ADDENDUM NUMBER TWO
RFQ # 7548779

TITLE: Furnish and Install Generator for Zambarano Hospital Waste Water Treatment Plant

RE: New Generator for Zambarano Hospital
Waste Water Treatment Facility Addendum #1
Solicitation No. 7548779
CEC Project No. 20130146

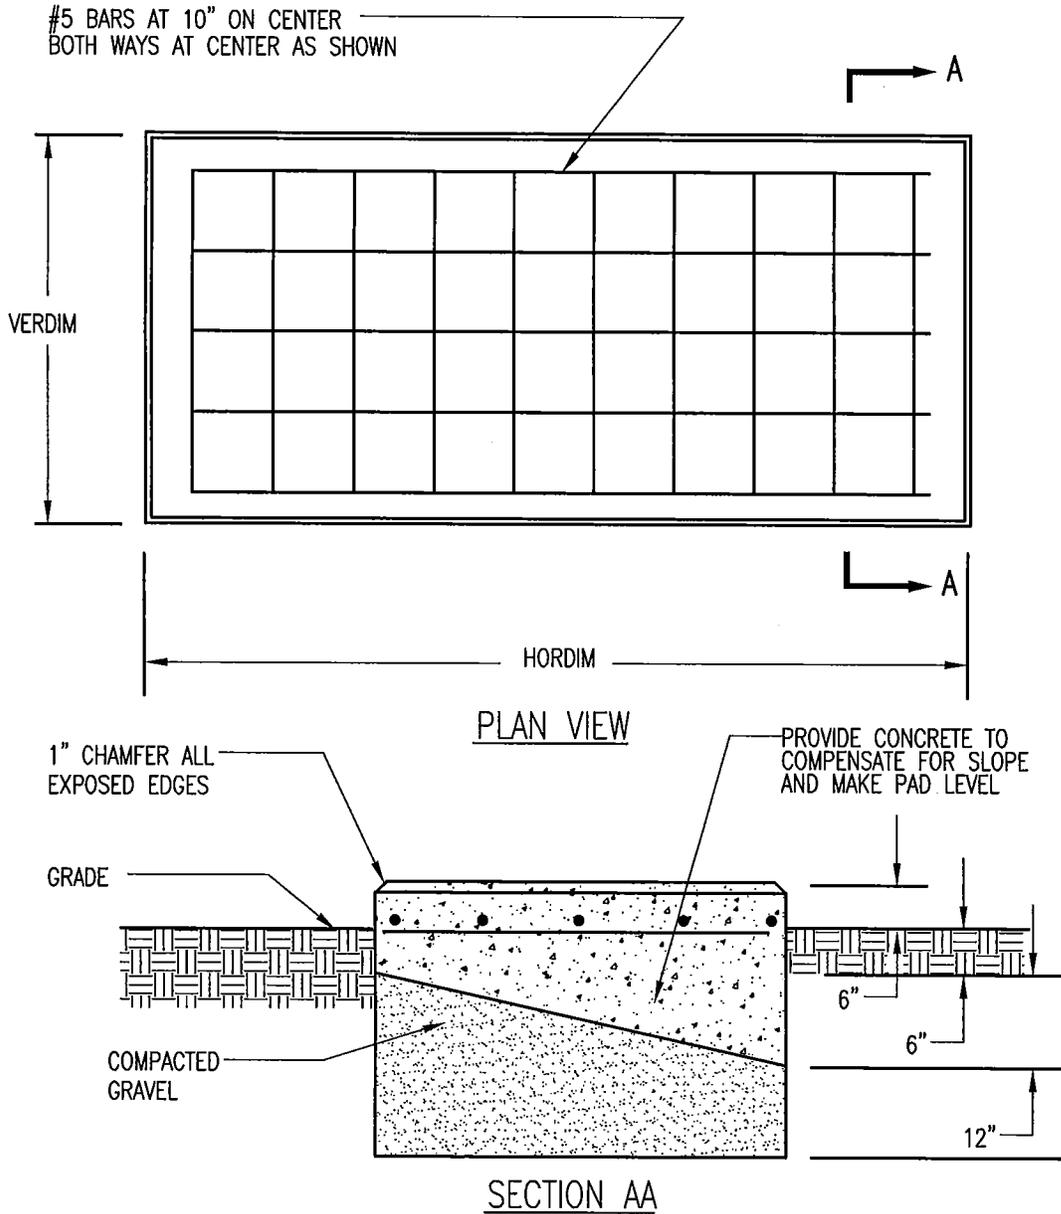
Item #8

Chain link fence required to be removed and shall be replaced by the contractor to the satisfaction of the Owner.
